REQUEST FOR COMMITTEE ACTION

HENDERSON COUNTY TECHINCAL REVIEW COMMITTEE

SUBJECT: Master and Development Plan for Skydance LLC Minor Subdivision (2019 – X33)

Combined Master and Development Plan For Skydance, LLC (2019-X33)

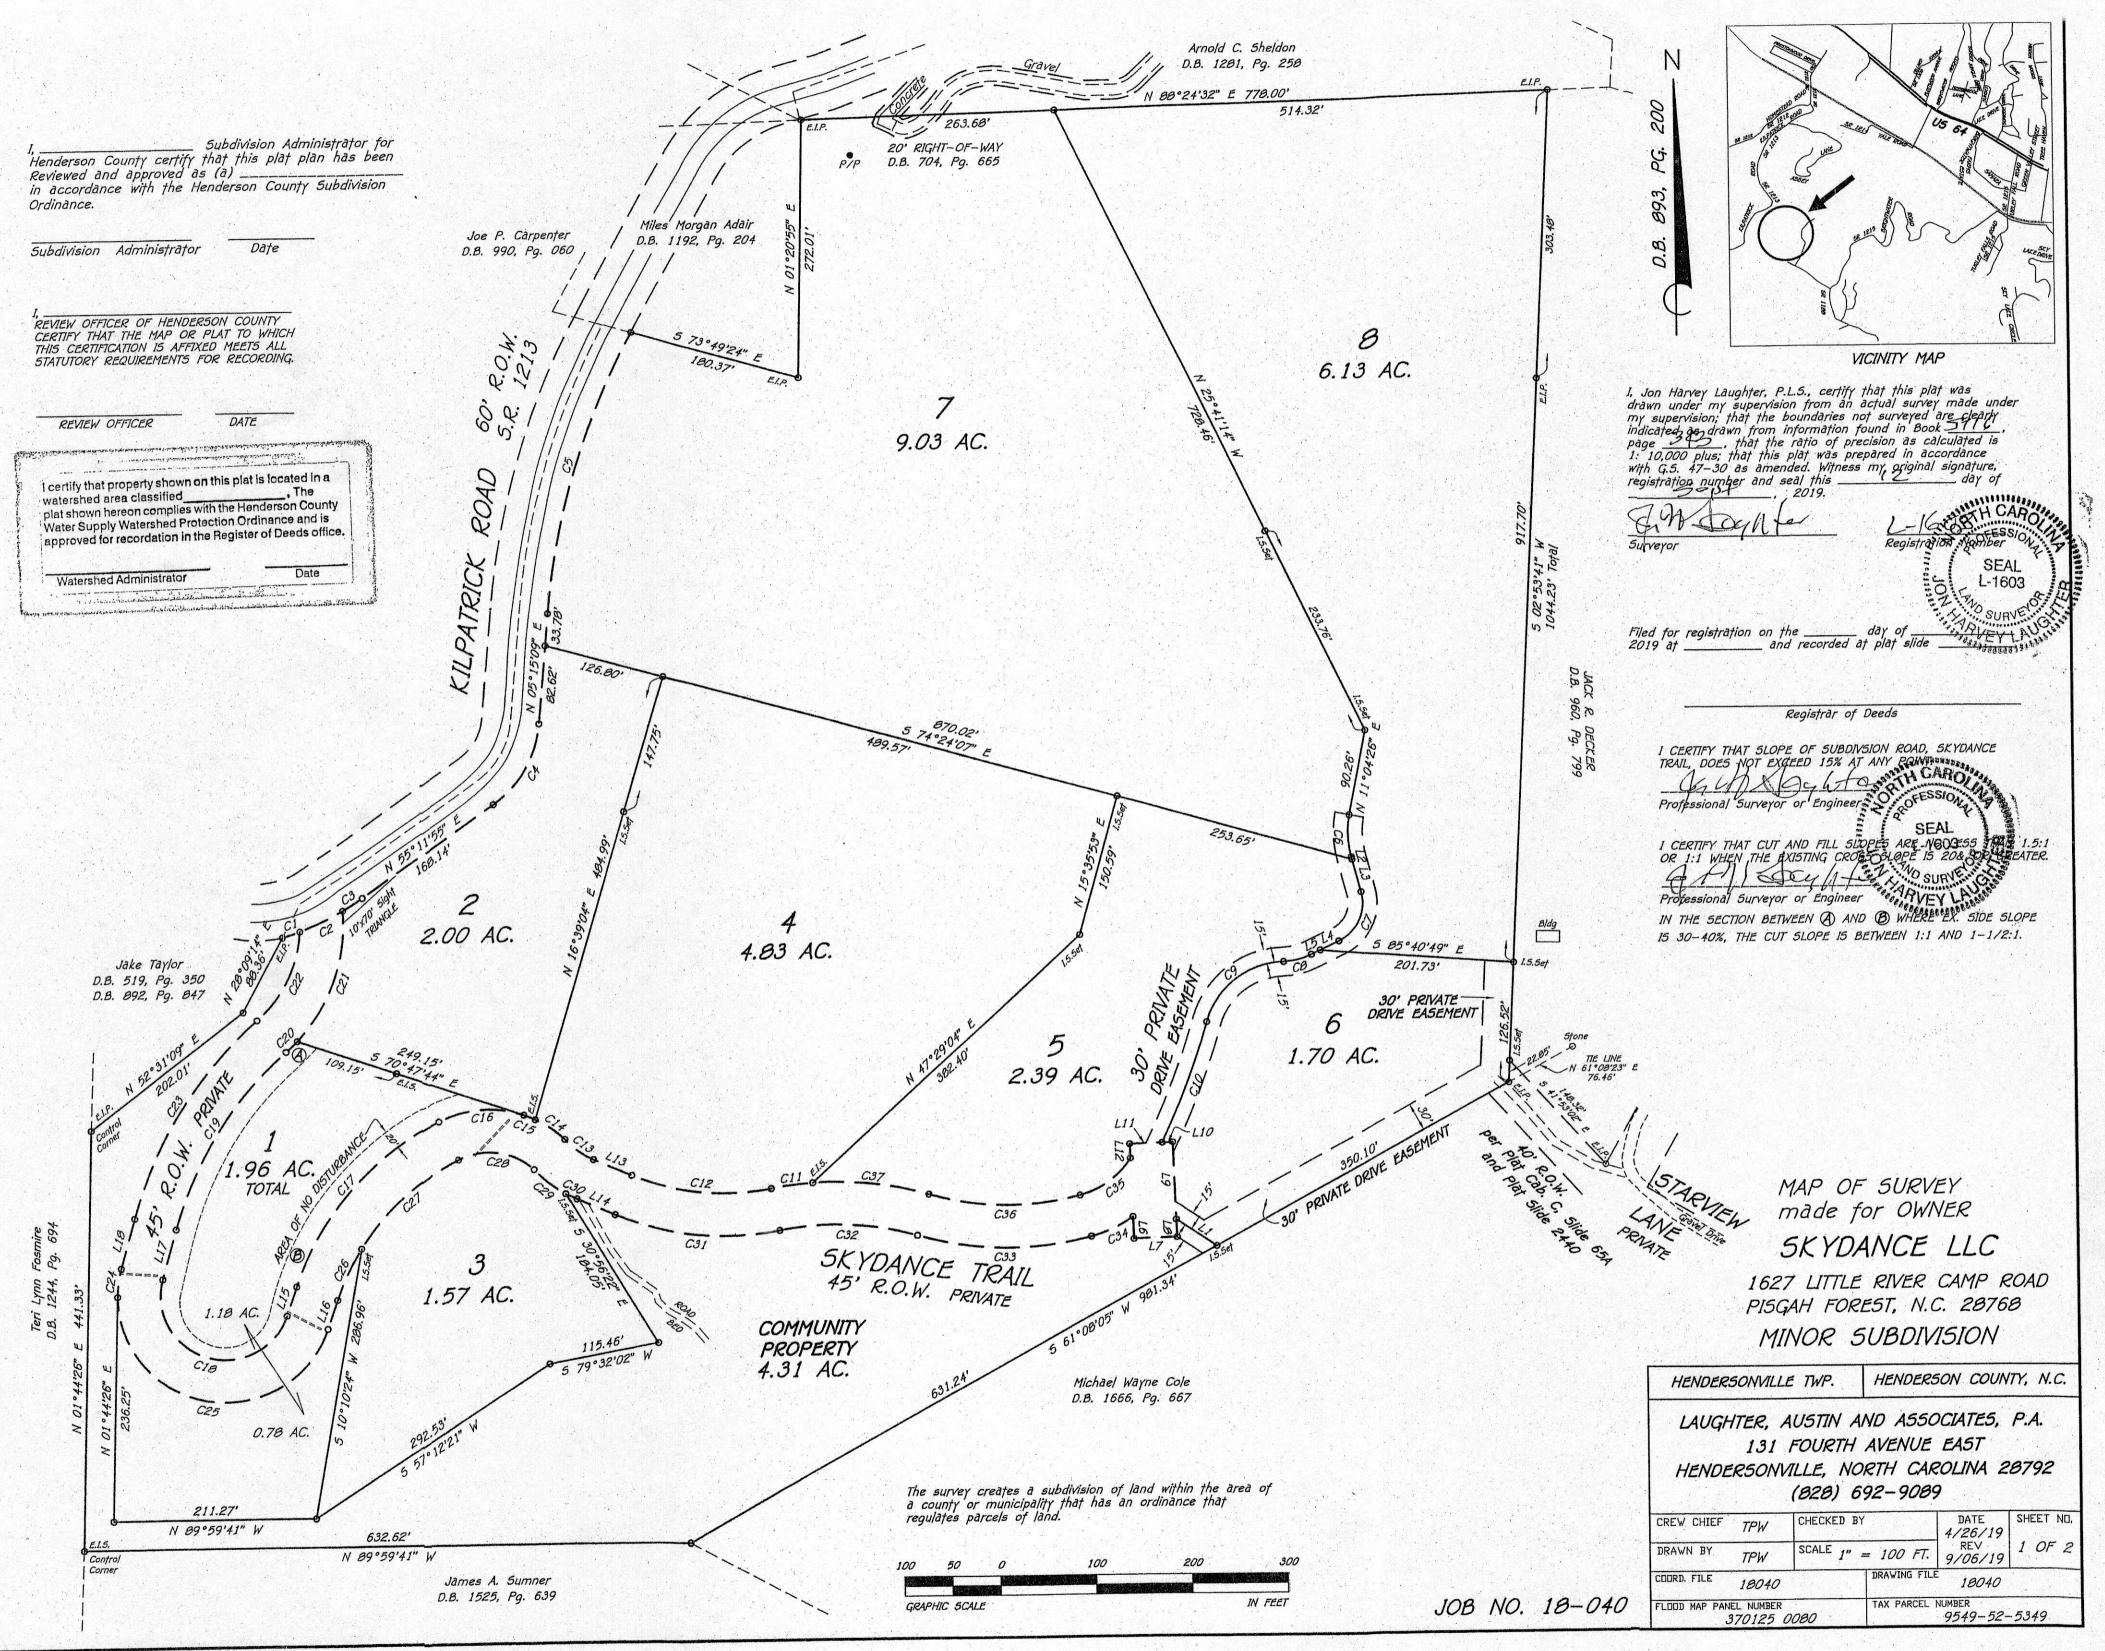
- 2. **Private Road Standards.** The Applicant must provide a cross section for the proposed roads. This cross section would need to indicate the road to be a subdivision local road. All subdivision roads must be designed and constructed to the minimum standards of LDC §42-81 C (Table 3.3).

- 3. **Road Grade.** The Applicant must identify the type of material utilized on the surface of the proposed private roads for the subdivision. The maximum road grade for local roads constructed of gravel is 15 percent and 18 percent for a paved surface. A professional engineer or professional land surveyor must certify on the Final Plat that no portion of the road has a grade that exceeds 15 or 18 percent or submit a final as-built graded center line profile showing grade and alignment of the road (LDC §42-81 C (Table 3.3). and §42-81 C (4)).

- 4. **Cul-de-sac**. The Applicant proposes one (1) cul-de-sacs or turnarounds located at the end of local road McKinley Drive. All turnarounds must meet of the LDC §42A-105 C (8).

- 5. **Gates.** The Applicant should become familiar with the Entry Gate provisions of Chapter 42A (LDC §42A-81 C(7)). All entry gates shall be constructed and maintained as required by and in accordance with Chapter 42 of the Henderson County Code, *Entry Gates*.

- 6. **Shoulder Stabilization.** All areas disturbed by the construction of a private road, including cut and fill slopes, shoulders and ditch banks, shall be seeded to stabilize the soil and prevent erosion. Seeding should be done as soon as feasible after road construction (LDC §42-81 E).
